**TO:** Jeff Weeder, Galloway and Company  
**FROM:** Amber Wood Hicken, Planner I  
**DATE:** 4/27/23  
**SUBJECT:** Lincoln Professional Park L3 – Andy’s Custard, Site Plan, SP23-113  
Review Comments 03

LINCOLN PROFESSIONAL PARK FILING NO.1 LOT 3

SITE PLAN DOCUMENTS

**2 BUILDING ELEVATION - NORTH FACE**  
 R002  
 1/4" = 1'-0"

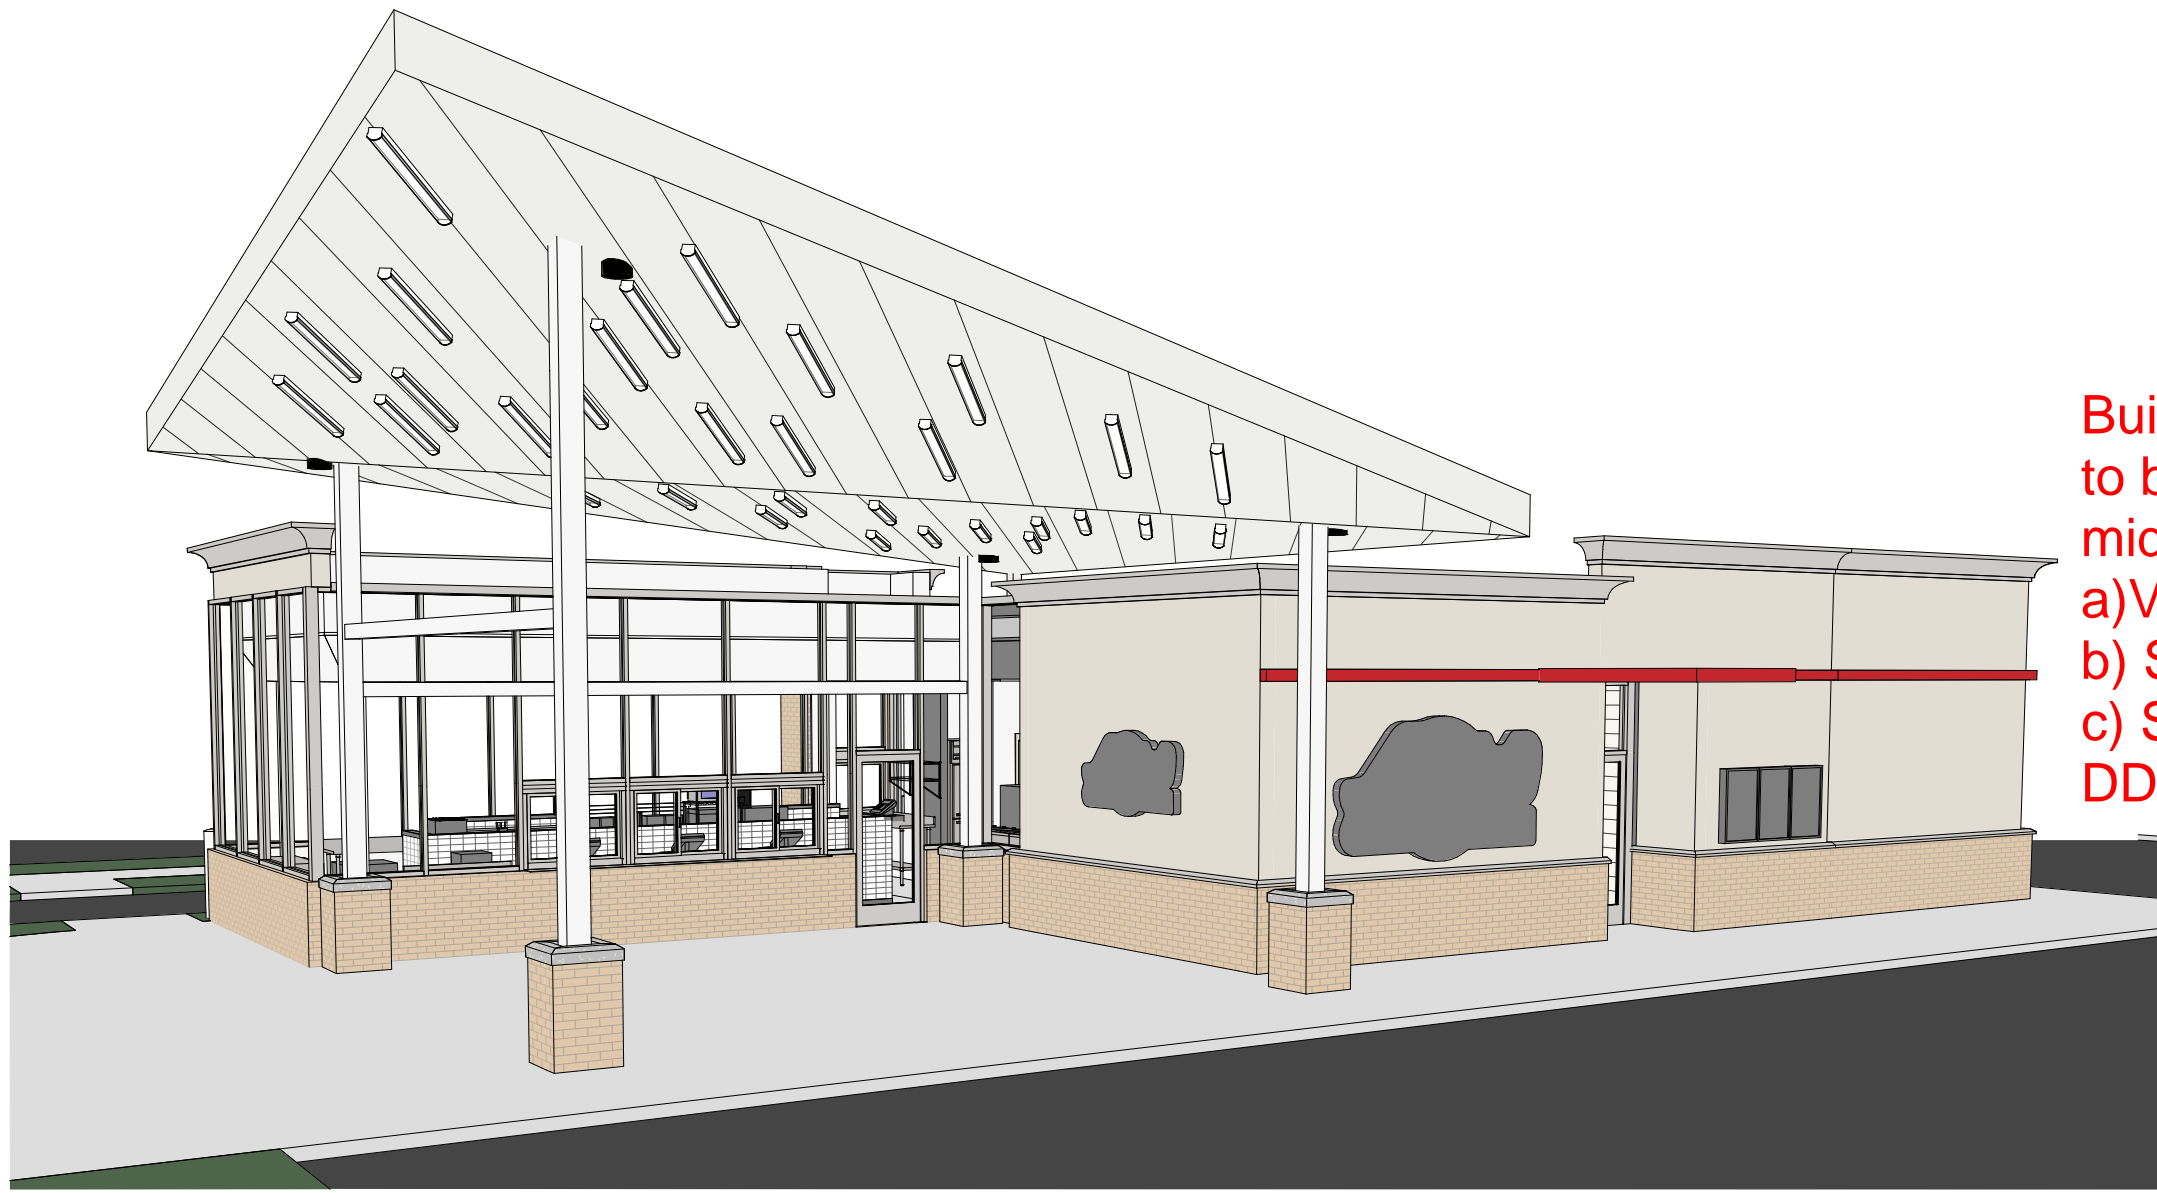
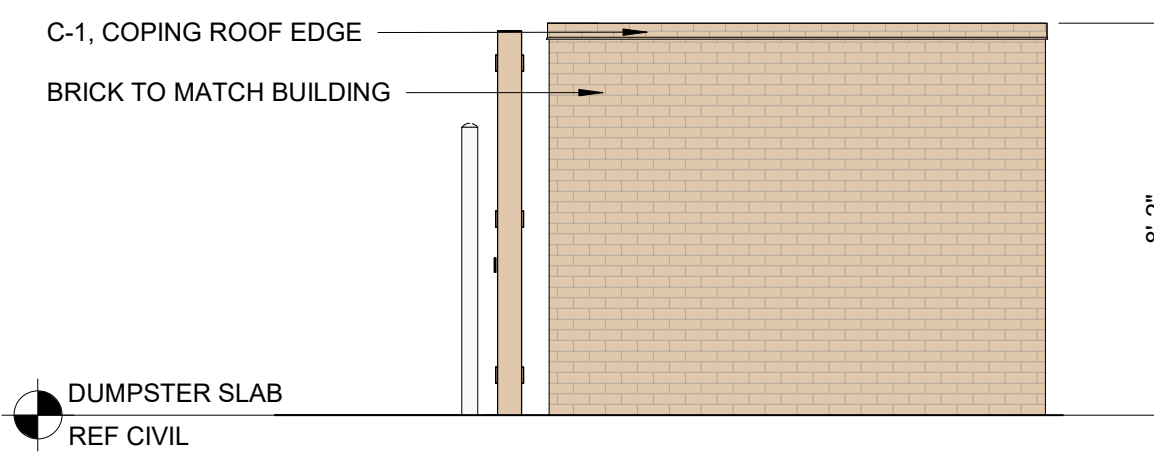
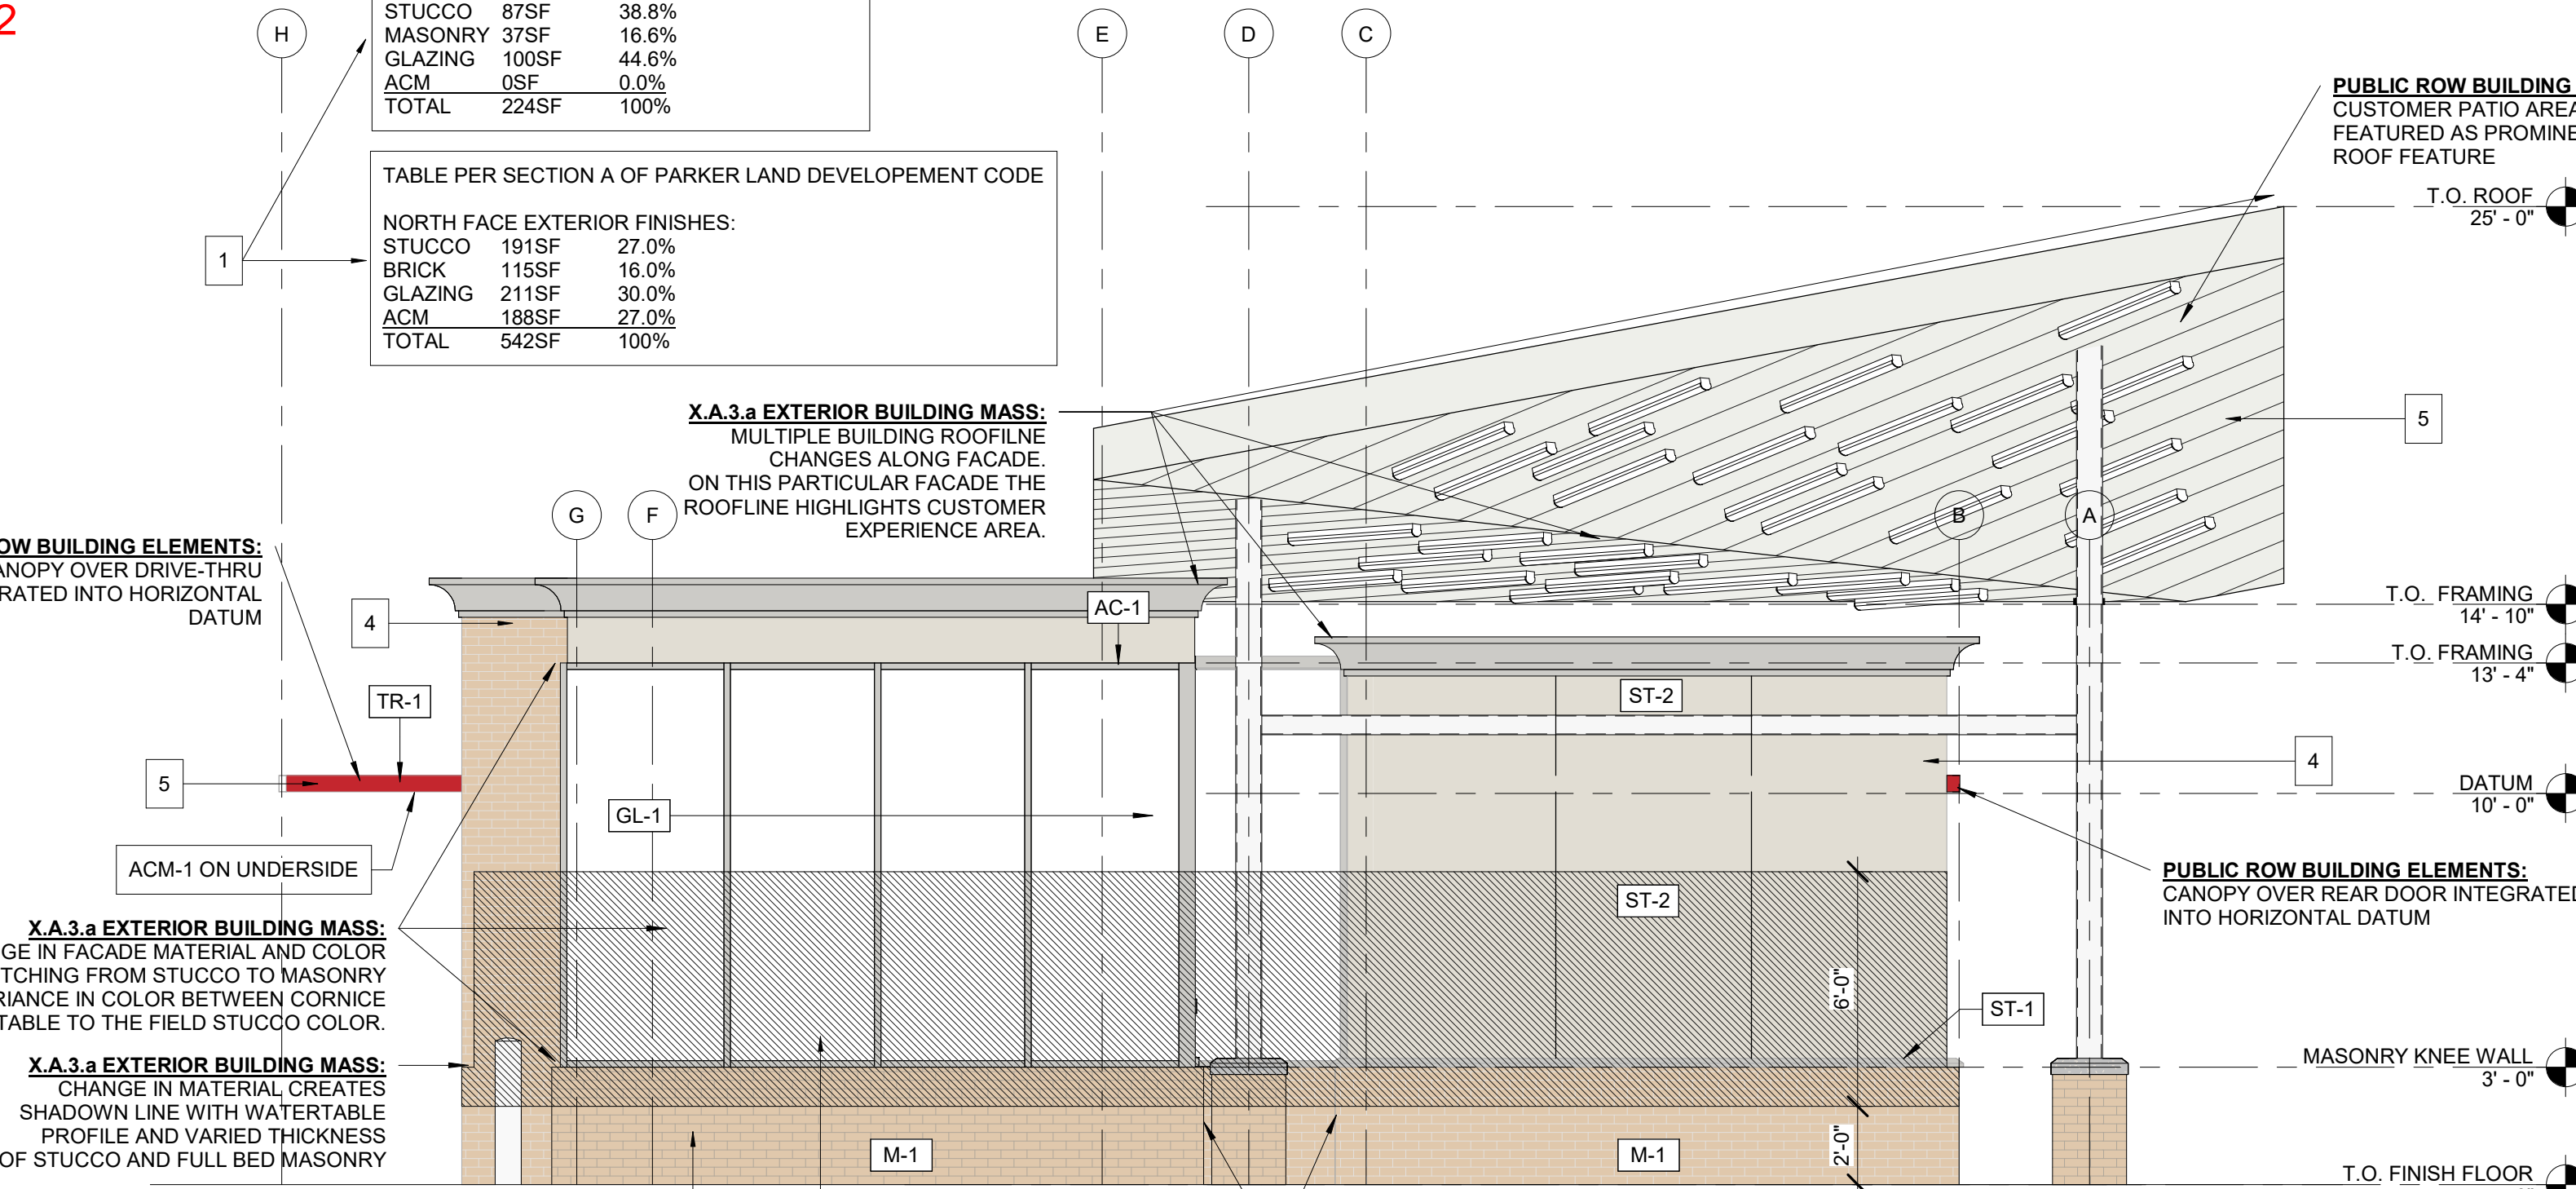
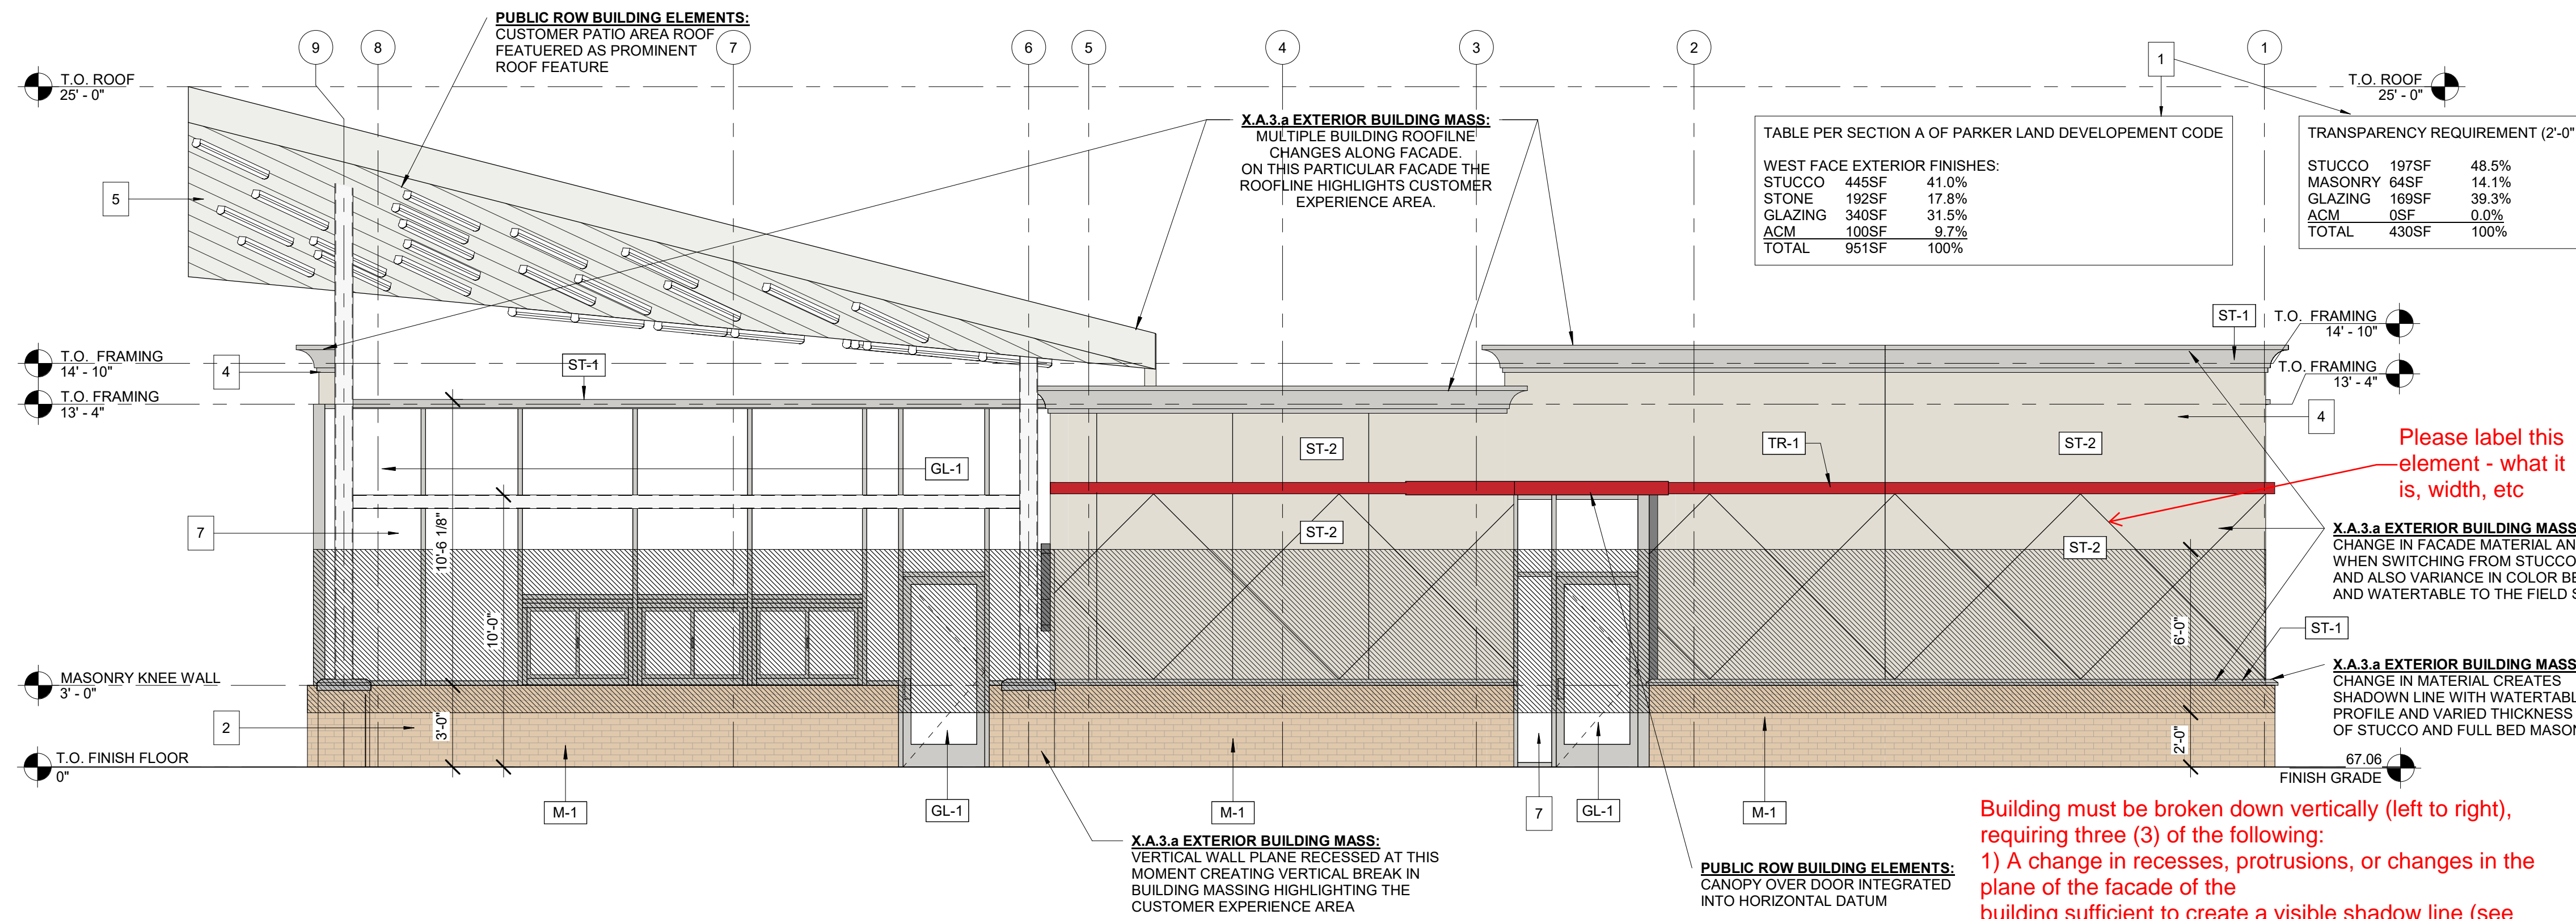
Building must be broken down horizontally (top to bottom) with a base, middle, and top. The middle should include:  
 a) Visibly apparent material change  
 b) String courses (horizontal banding)  
 c) Stepbacks, recesses or protrusions  
 DDS, pg 52

Building must be broken down vertically (left to right), requiring three (3) of the following:  
 1) A change in recesses, protrusions, or changes in the plane of the facade of the building sufficient to create a visible shadow line (see figure 71).  
 2) A significant break in the eave line or roof form  
 3) A change in facade material or color  
 DDS, pg 53
